ADDENDUM NO. 3
CITY OF NORPHLET
WASTEWATER PIPELINE
18 October 2018

ADDENDUM NO. 2
CITY OF NORPHLET
WASTEWATER PIPELINE
18 October 2018

ADDENDUM NO. 1
CITY OF NORPHLET
WASTEWATER PIPELINE
15 October 2018

**CITY OF NORPHLET
 WASTEWATER PIPELINE**

DESIGNED BY	CHECKED BY	DATE: 01/2018	JOB NO:	ITEM NO:
DRAWN BY	APPROVED BY	SCALE: NTS	DRAWING NUMBER: 4	REV.:

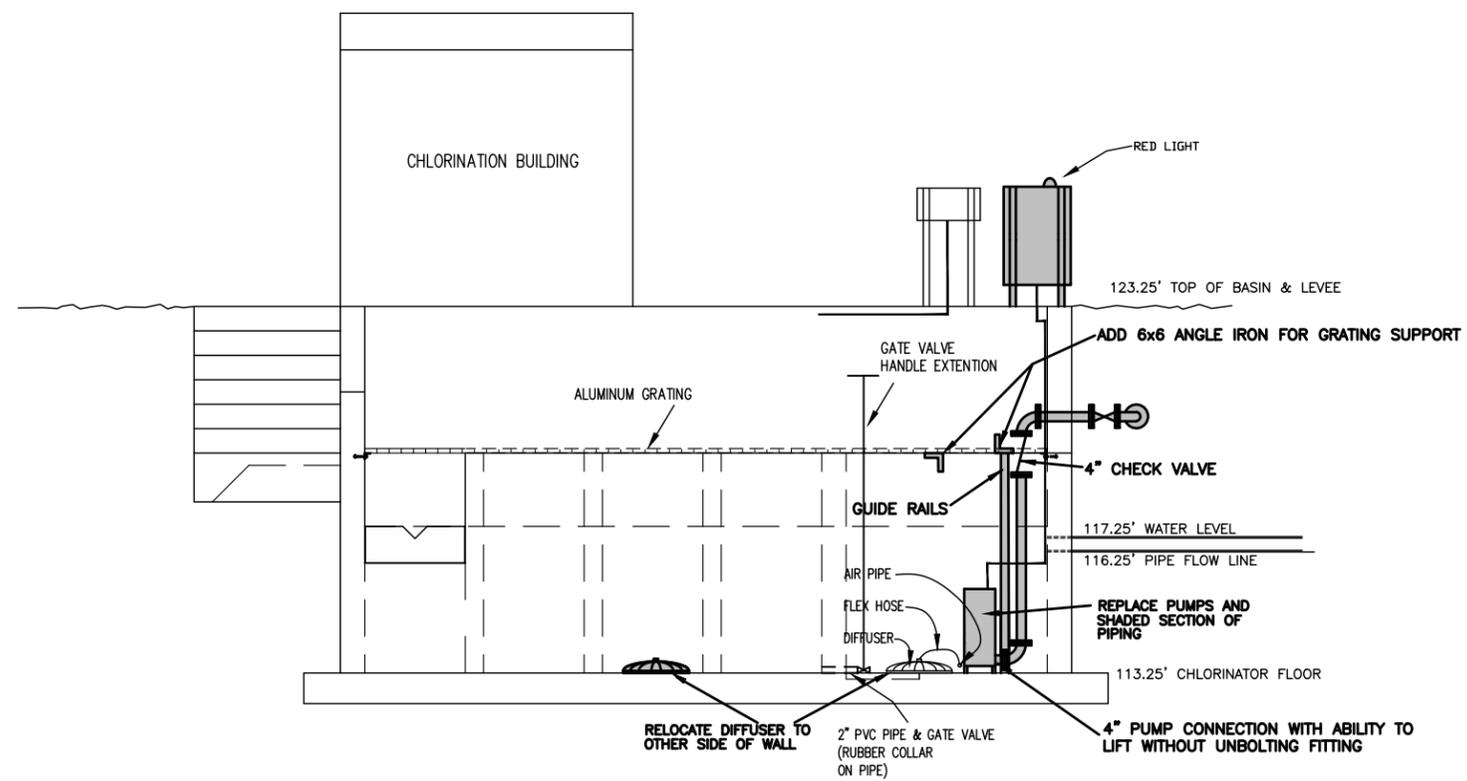
1. Attached is revised sheet no. 4. The 3-inch mag meter is now the only flow meter to be added; the existing flow meter will still remain in place.

1. Attached is revised sheet no. 4 showing the piping to and from the flow meter.
2. As shown on the revised sheet 4, a meter box has been added to protect the flow meter from the elements.

ADDENDUM 3 - DELETE EXTRA FLOW METER	10/18/18		
ADDENDUM 2 - ADD MAGMETER & BOX	10/18/18		
ADDENDUM NO. 1	10/15/18		
PUMPS AND FLOW METER TO BE REPLACED	03/2018		
REV.	DESCRIPTION	CHK.	DATE
